NOTICE OF VIOLATION

INSPECTION REPORT

Electrical Corporation:	Liberty Utilities (LU)			
Report Number:	LU_CAC18_20231031_1007			
Inspector:	CAC18			
WMP Year Inspected:	2023			
Quarterly Data Report (QDR) Referenced:	Quarter 2 (Q2)			
Inspection Selection:	Energy Safety viewed the contents of the Q2 QDR and performed an analysis that resulted in the selection of			
	the WMP initiatives and locations referenced in this report.			
Relevant WMP Initiative(s):	Clearance (2023 WMP initiative number 8.2.3.3)			
Date of inspection:	October 31, 2023			
City and/or County of Inspection:	Coleville, Mono County			
Inspection Purpose:	Assess the accuracy of Liberty Utilities' QDR data, completeness of its work, compliance with WMP			
	requirements, and compliance with its protocols.

Exhibit A: Photo Log **Structure ID:** 158410 Violation 1

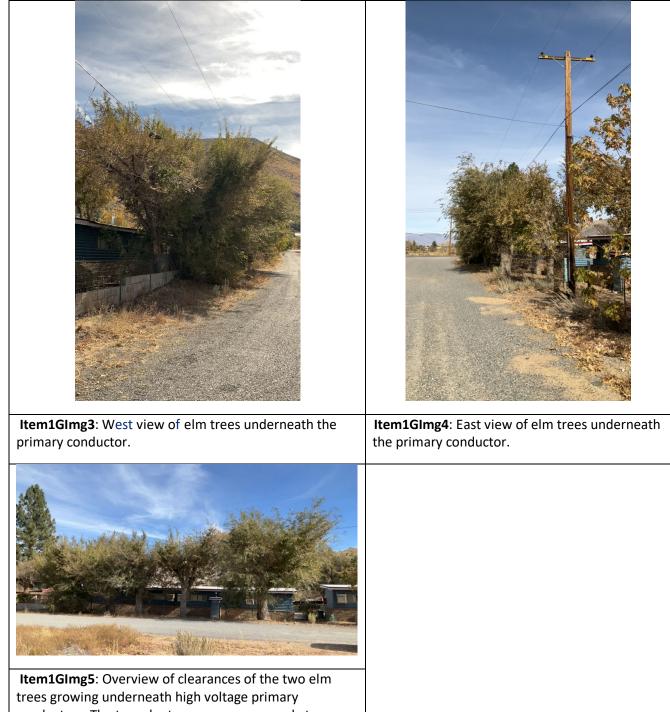
Near pole ID 158410 at 107045 US Highway 395, Coleville, CA, 96107, USA, 38.5128587072477, -119.470726209569, the inspector observed one elm tree approximately three feet and another elm tree approximately five feet below the primary conductors. The inspector's observations are documented in Violation 1 photographs, which are attachments to this report. Photograph numbers Item1GImg1, Item1GImg2, Item1GImg3, Item1GImg4, and Item1GImg5 depict an elm tree approximately three feet under primary conductors and a second elm tree approximately five feet under primary conductors. The radial clearance requirement from these primary conductors (12kV-25kV) is six feet, and Liberty Utilities failed to trim back to 12-15 feet, per Liberty Utilities' MAT shown in Table 8-23 above.

- 2. Two elm trees were within six feet of primary conductors.
- 3. Liberty Utilities did not achieve vegetation clearance of between 12 and 15 feet from primary conductors.

conductors. The two elm trees were measured at approximately three feet and five feet under primary conductors.

⁸ Liberty Utilities, "2023 Wildfire Mitigation Plan Rev 2," October 6, 2023. p. 228. [Online] Available: <u>https://efiling.energysafety.ca.gov/eFiling/Getfile.aspx?fileid=55765&shareable=true</u>. The relevant standard applied in this NOV is that vegetation found to be within six feet of a 12kV – 25kV conductor must be trimmed so that it is 12-15 feet from the conductor depending on the growth rate of the vegetation.
